ADDENDUM # 01

Blue Ridge Community College

One Stop - Renovation Phase II

SCO ID# 18-18892-01A

PARTITION TYPES
A-002

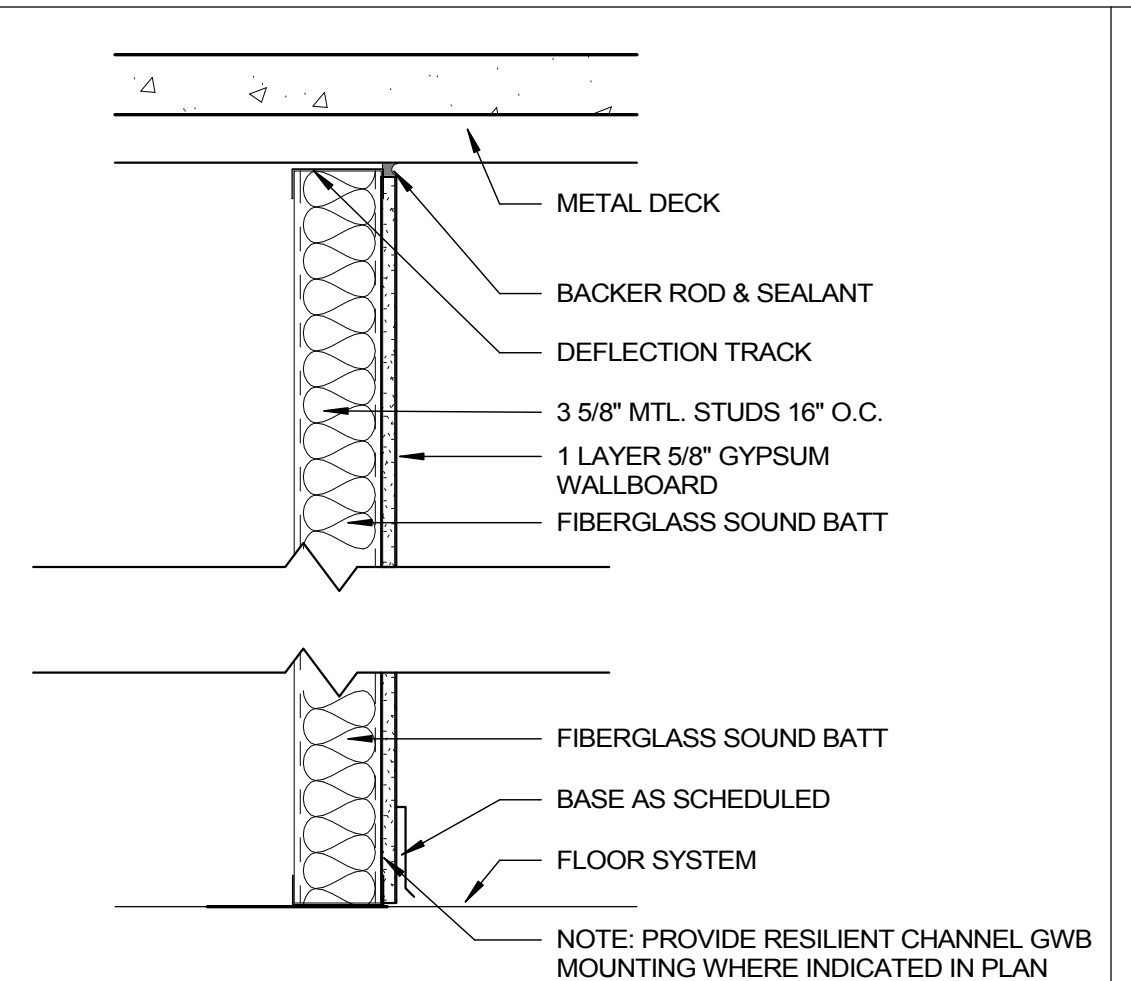
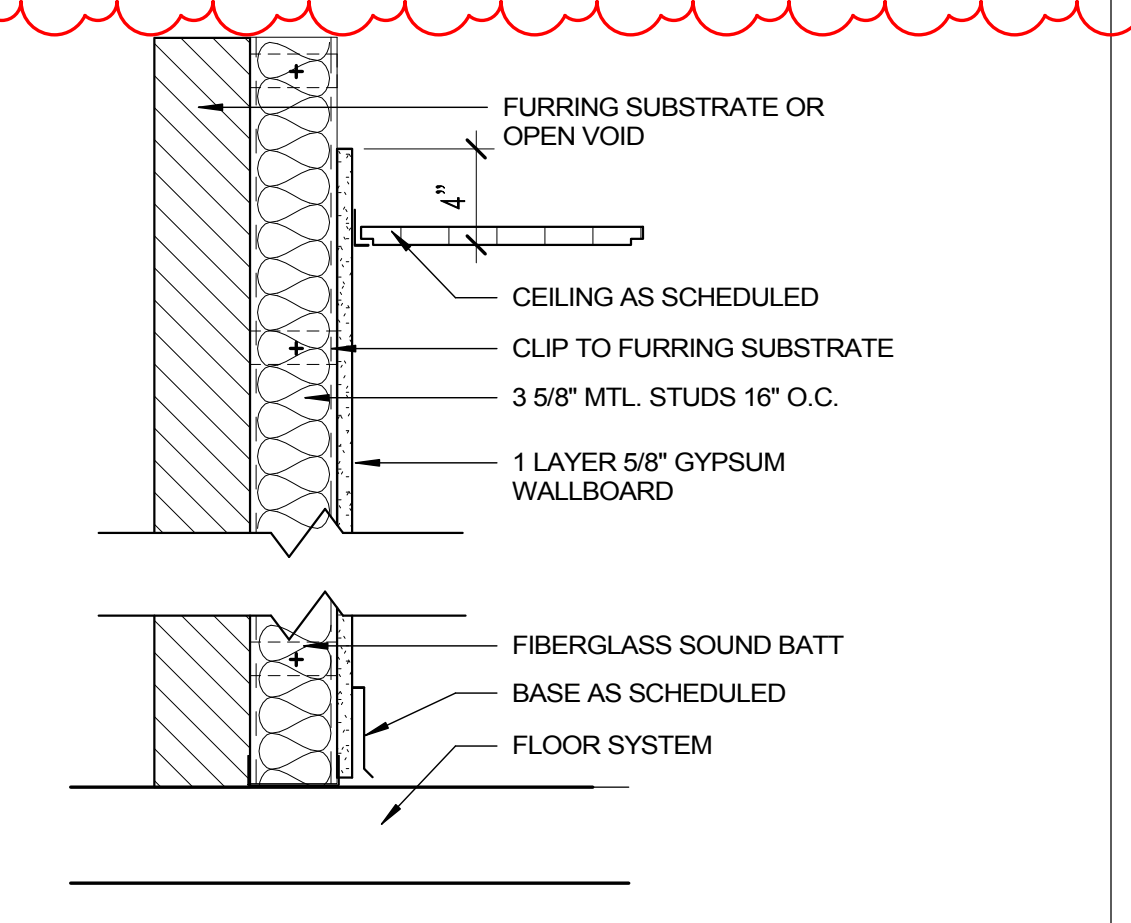
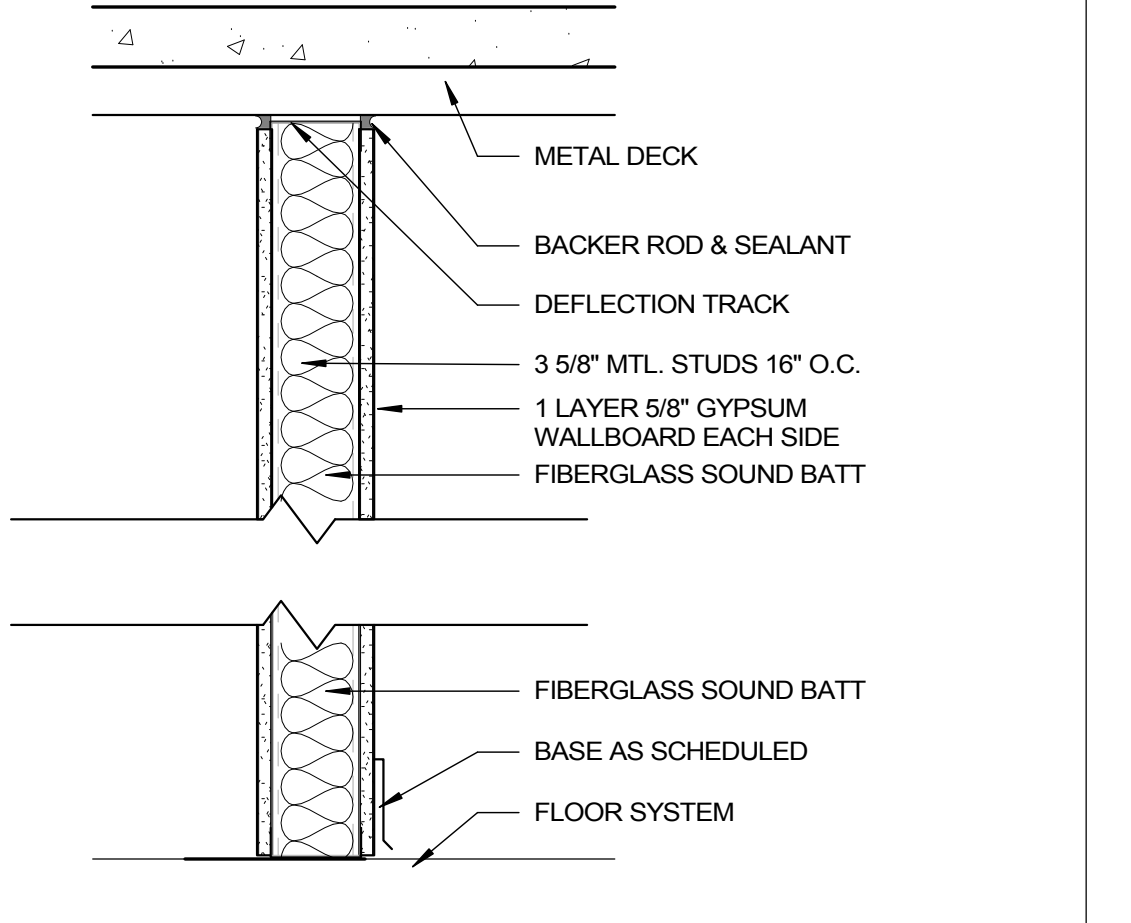
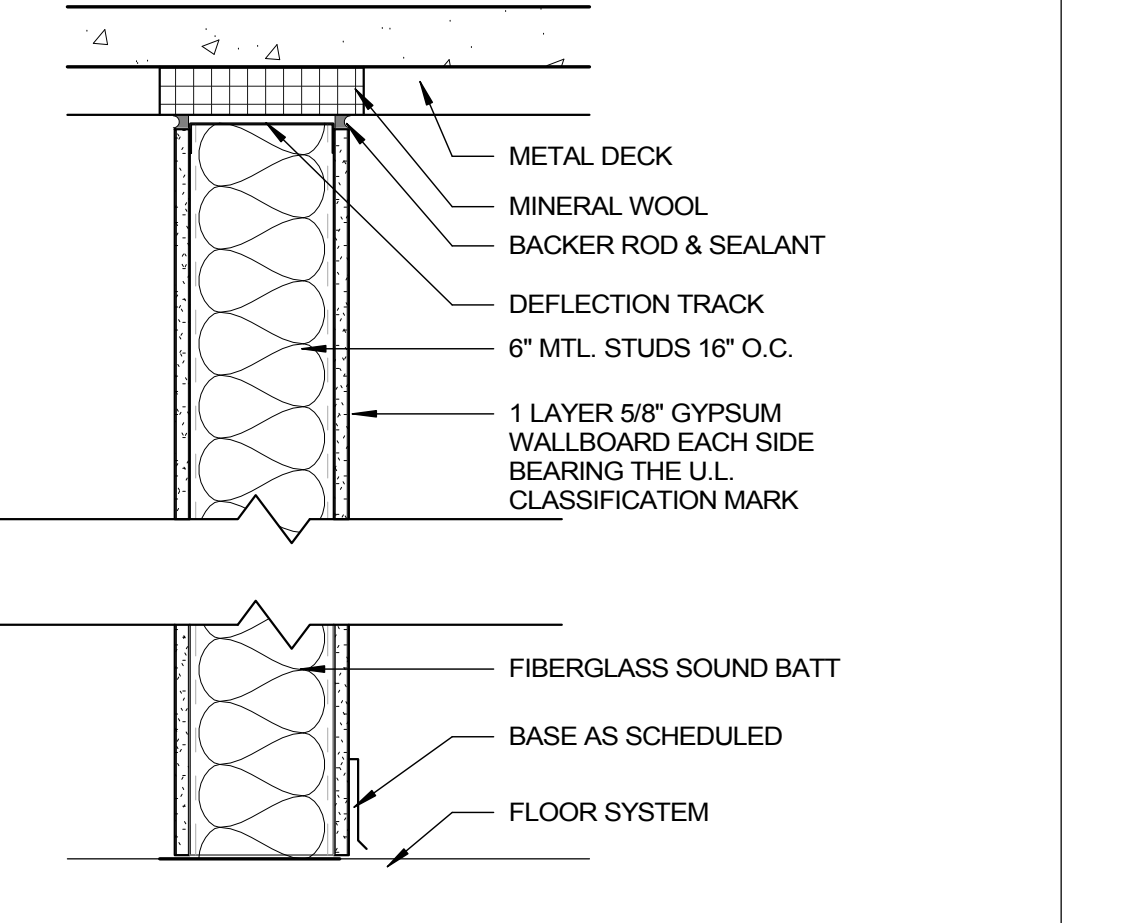
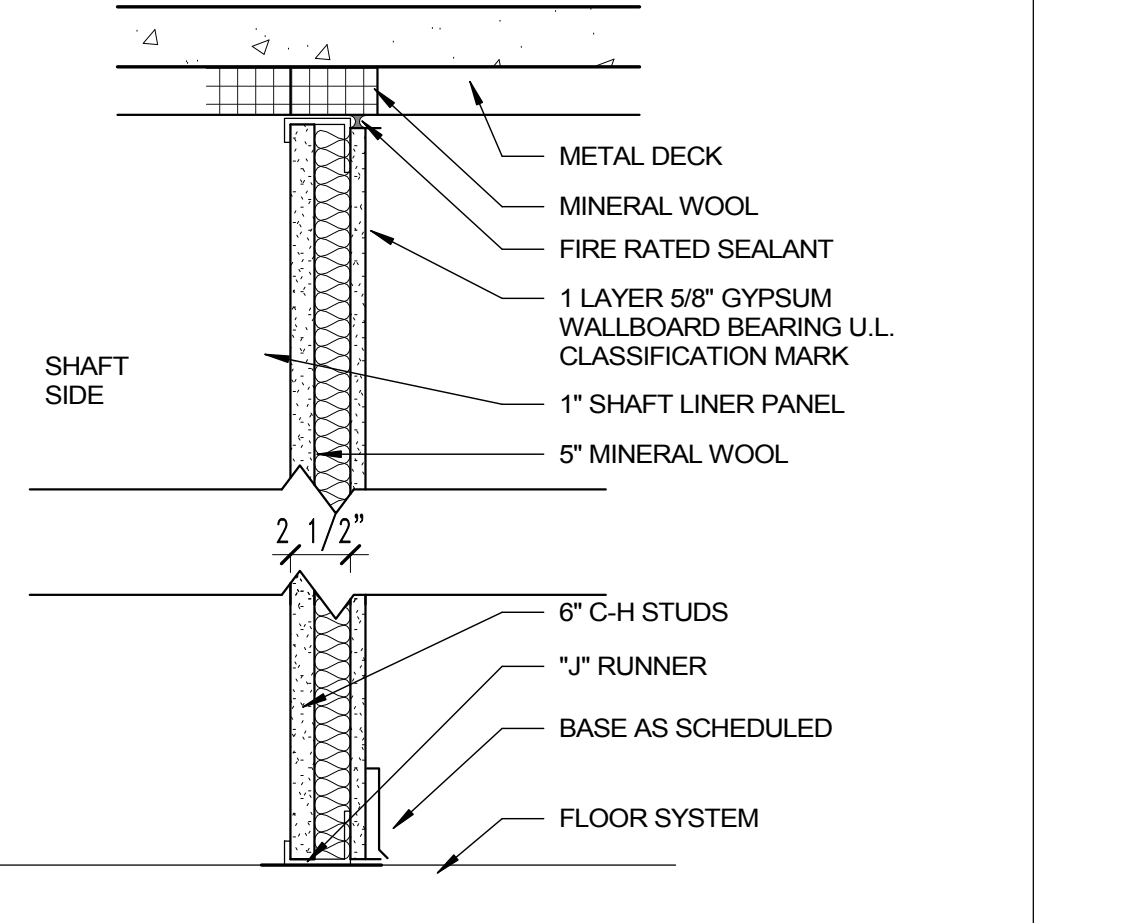
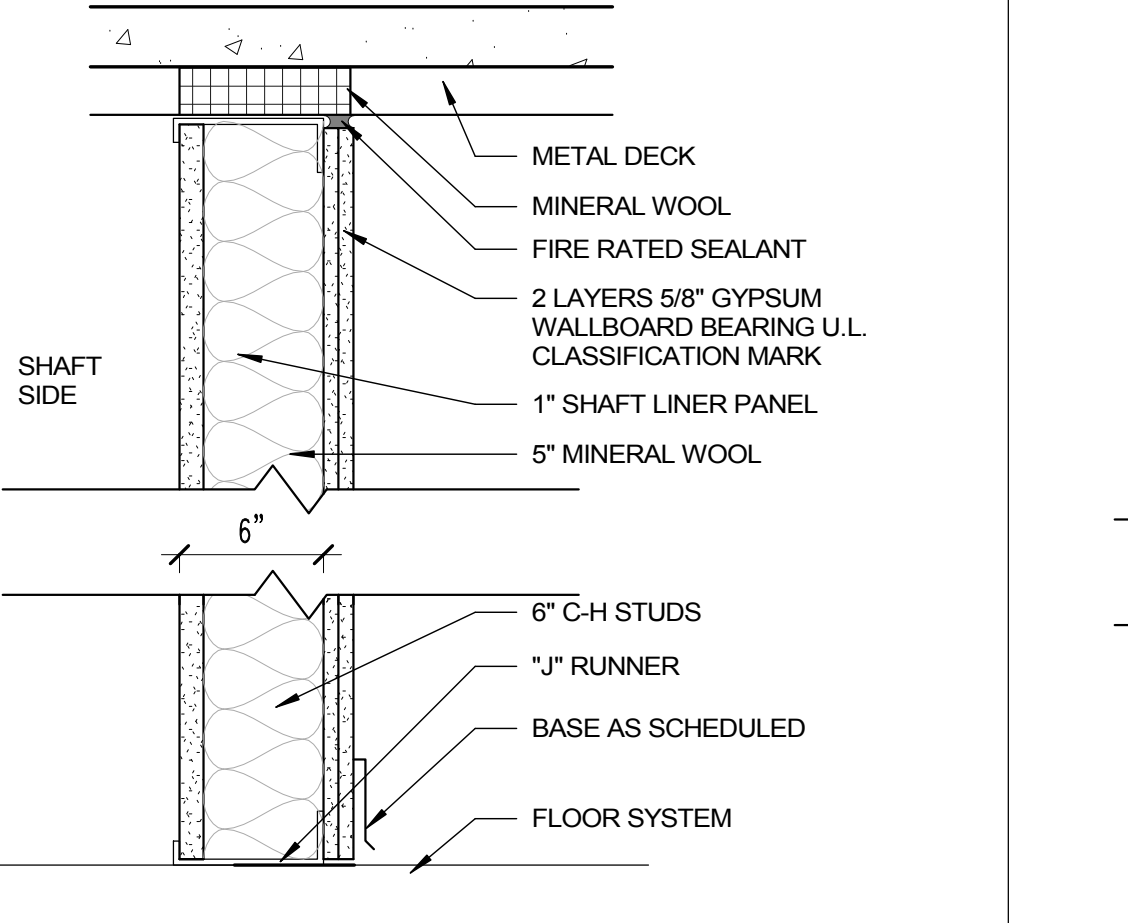
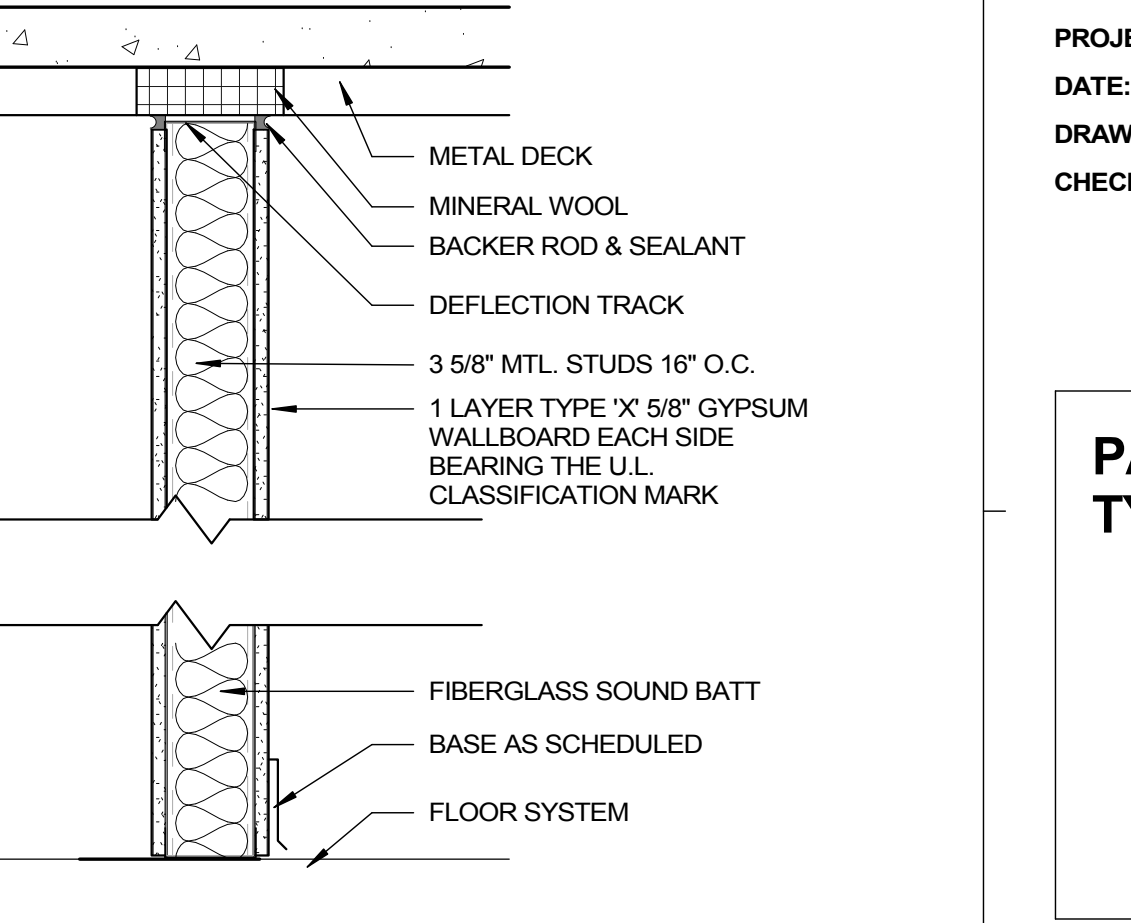
- 3.1 G-101 – LIFE SAFETY PLANS: Updated temporary barrier information.
- 3.2 A-002 – PARTITION TYPES: Updated partition type for walls at restrooms to extend to deck.
- 3.3 A-101 – FIRST FLOOR PLAN: Provided clarity for renovated components, wall types.
- 3.4 A-401 - ENLARGED PLANS: Updated restroom accessories information
- 3.5 A-601 – DOOR SCHEDULE, DOOR TYPE LEGEND & FRAME TYPES: Updated door information.
